| ITEM: 6.6 | COMMITTEE OF ADJUSTMENT REPORT SUMMARY MINOR VARIANCE APPLICATION FILE NUMBER A175/23 31 QUAIL RUN BLVD, MAPLE |

**COMMITTEE OF ADJUSTMENT REPORT
MINOR VARIANCE APPLICATION
A175/23
31 QUAIL RUN BLVD, MAPLE**

| PURPOSE OF APPLICATION: | Relief from the Zoning By-law is being requested to permit a proposed cabana. |

OWNER: XXX
DRAWING: SUBMISSION PLAN
SCALE: 1:500
DATE: DEC 8, 2023
DRAWN BY: AZ
PROJ. No: L1

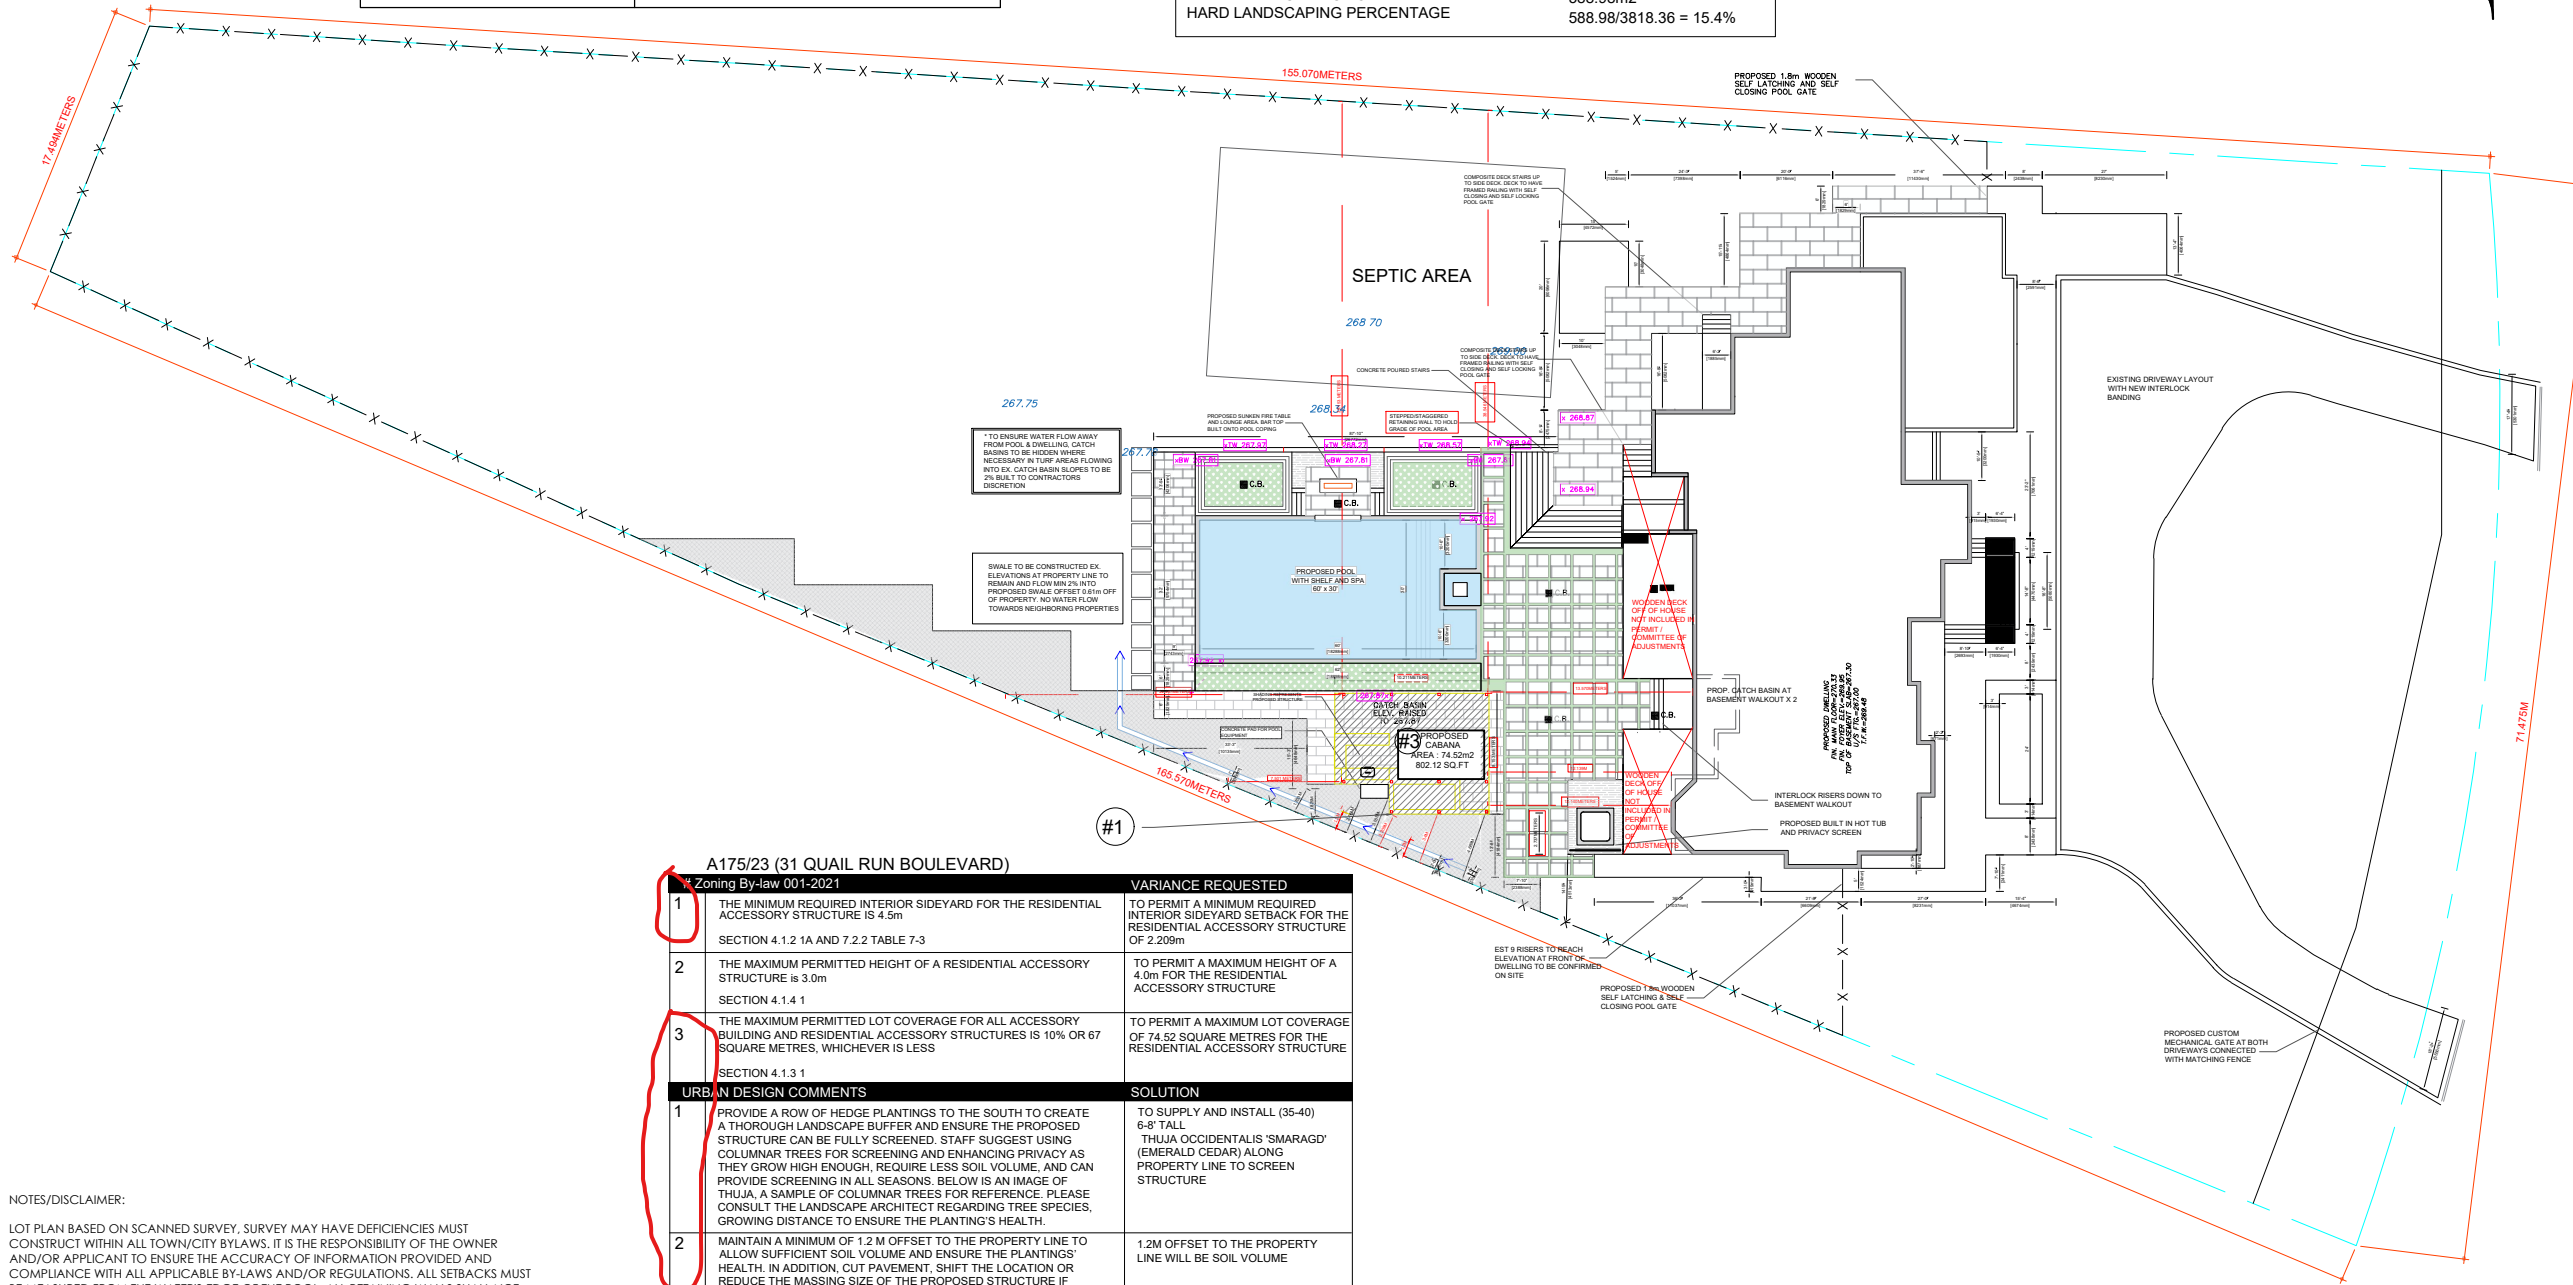
A175/23 (31 QUAIL RUN BOULEVARD)
Zoning By-law 001-2021
VARIANCE REQUESTED
1 THE MINIMUM REQUIRED INTERIOR SIDEYARD FOR THE RESIDENTIAL ACCESSORY STRUCTURE IS 4.5m TO PERMIT A MINIMUM REQUIRED INTERIOR SIDEYARD SETBACK FOR THE RESIDENTIAL ACCESSORY STRUCTURE OF 2.209m
2 THE MAXIMUM PERMITTED HEIGHT OF A RESIDENTIAL ACCESSORY STRUCTURE IS 3.0m TO PERMIT A MAXIMUM HEIGHT OF A 4.0m FOR THE RESIDENTIAL ACCESSORY STRUCTURE
3 THE MAXIMUM PERMITTED LOT COVERAGE FOR ALL ACCESSORY BUILDING AND RESIDENTIAL ACCESSORY STRUCTURES IS 10% OR 67 SQUARE METRES, WHICHEVER IS LESS TO PERMIT A MAXIMUM LOT COVERAGE OF 74.52 SQUARE METRES FOR THE RESIDENTIAL ACCESSORY STRUCTURE
URBAN DESIGN COMMENTS SOLUTION
1 PROVIDE A ROW OF HEDGE PLANTINGS TO THE SOUTH TO CREATE A THOROUGH LANDSCAPE BUFFER AND ENSURE THE PROPOSED STRUCTURE CAN BE FULLY SCREENED. STAFF SUGGEST USING COLUMNAR TREES FOR SCREENING AND ENHANCING PRIVACY AS THEY GROW HIGH ENOUGH, REQUIRE LESS SOIL VOLUME, AND CAN PROVIDE SCREENING IN ALL SEASONS. BELOW IS AN IMAGE OF THUJA, A SAMPLE OF COLUMNAR TREES FOR REFERENCE. PLEASE CONSULT THE LANDSCAPE ARCHITECT REGARDING TREE SPECIES, GROWING DISTANCE TO ENSURE THE PLANTING'S HEALTH. TO SUPPLY AND INSTALL (35-40) 6-8' TALL THUJA OCCIDENTALIS 'SMARAGD' (EMERALD CEDAR) ALONG PROPERTY LINE TO SCREEN STRUCTURE

2 MAINTAIN A MINIMUM OF 1.2 M OFFSET TO THE PROPERTY LINE TO ALLOW SUFFICIENT SOIL VOLUME AND ENSURE THE PLANTINGS' HEALTH. IN ADDITION, CUT PAVEMENT, SHIFT THE LOCATION OR REDUCE THE MASSING SIZE OF THE PROPOSED STRUCTURE IF NECESSARY TO ACHIEVE THE MINIMUM OFFSET. 1.2M OFFSET TO THE PROPERTY LINE WILL BE SOIL VOLUME

L2

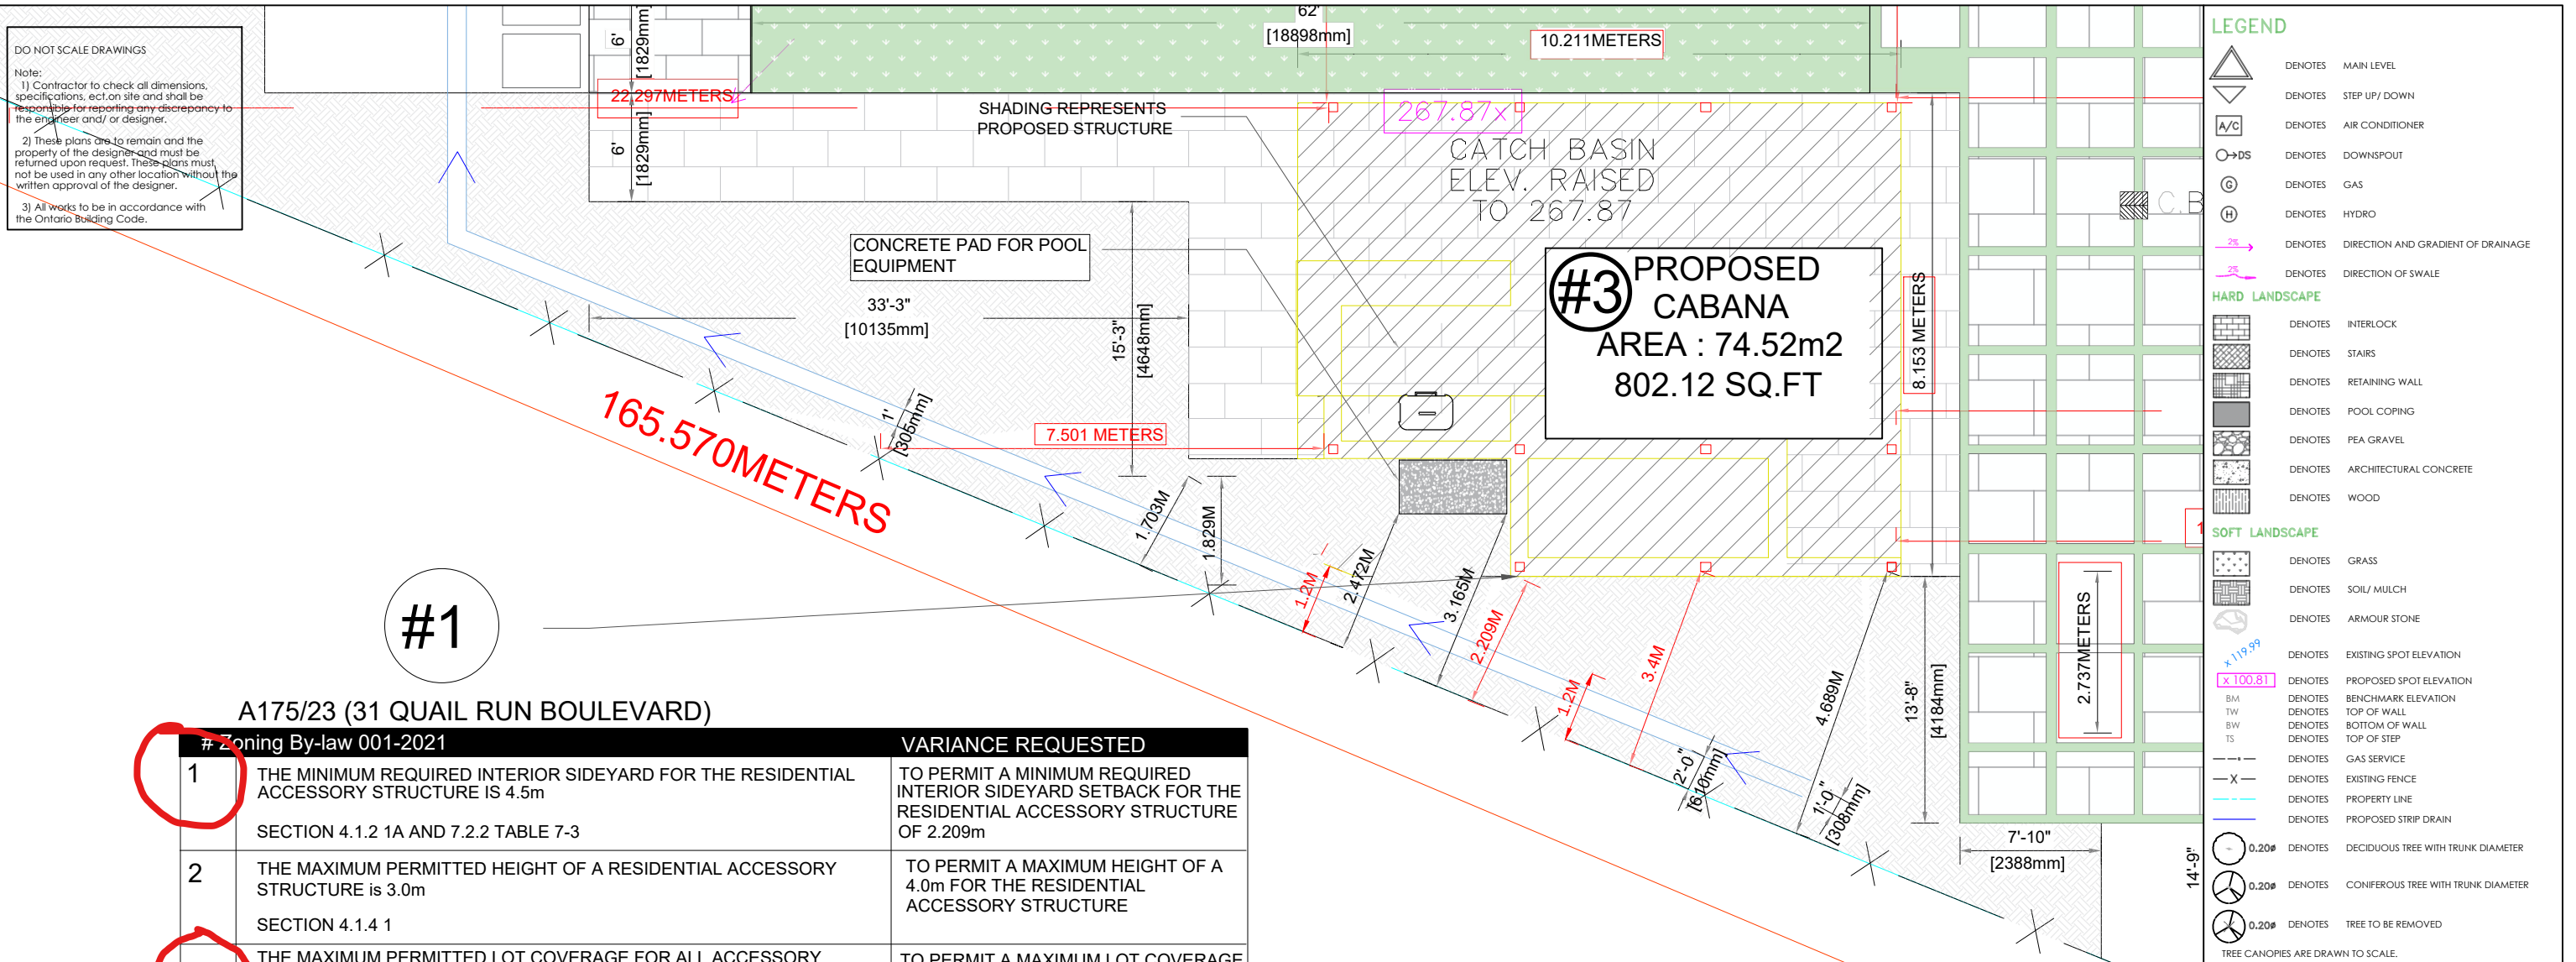
| # | Zoning By-law 001-2021 | VARIANCE REQUESTED |
|-----------------------|----------------------------------------------------------------------------------------------------------------------------------------------------------------------------------------------------------------------------------------------------------------------------------------------------------------------------------------------------------------------------------------------------------------------------------------------------------------------------------------------------------|-------------------------------------------------------------------------------------------------------------------------------|
| 1 | PROVIDE A ROW OF HEDGE PLANTINGS TO THE SOUTH TO CREATE A THOROUGH LANDSCAPE BUFFER AND ENSURE THE PROPOSED STRUCTURE CAN BE FULLY SCREENED. STAFF SUGGEST USING COLUMNAR TREES FOR SCREENING AND ENHANCING PRIVACY AS THEY GROW HIGH ENOUGH, REQUIRE LESS SOIL VOLUME, AND CAN PROVIDE SCREENING IN ALL SEASONS. BELOW IS AN IMAGE OF THUJA, A SAMPLE OF COLUMNAR TREES FOR REFERENCE. PLEASE CONSULT THE LANDSCAPE ARCHITECT REGARDING TREE SPECIES, GROWING DISTANCE TO ENSURE THE PLANTING'S HEALTH. | TO SUPPLY AND INSTALL (35-40) 6-8' TALL 'THUJA OCCIDENTALIS 'SMARAGD' (EMERALD CEDAR) ALONG PROPERTY LINE TO SCREEN STRUCTURE |
| 2 | MAINTAIN A MINIMUM OF 1.2 M OFFSET TO THE PROPERTY LINE TO ALLOW SUFFICIENT SOIL VOLUME AND ENSURE THE PLANTINGS' HEALTH. IN ADDITION, CUT PAVEMENT, SHIFT THE LOCATION OR REDUCE THE MASSING SIZE OF THE PROPOSED STRUCTURE IF NECESSARY TO ACHIEVE THE MINIMUM OFFSET. | 1.2M OFFSET TO THE PROPERTY LINE WILL BE SOIL VOLUME |
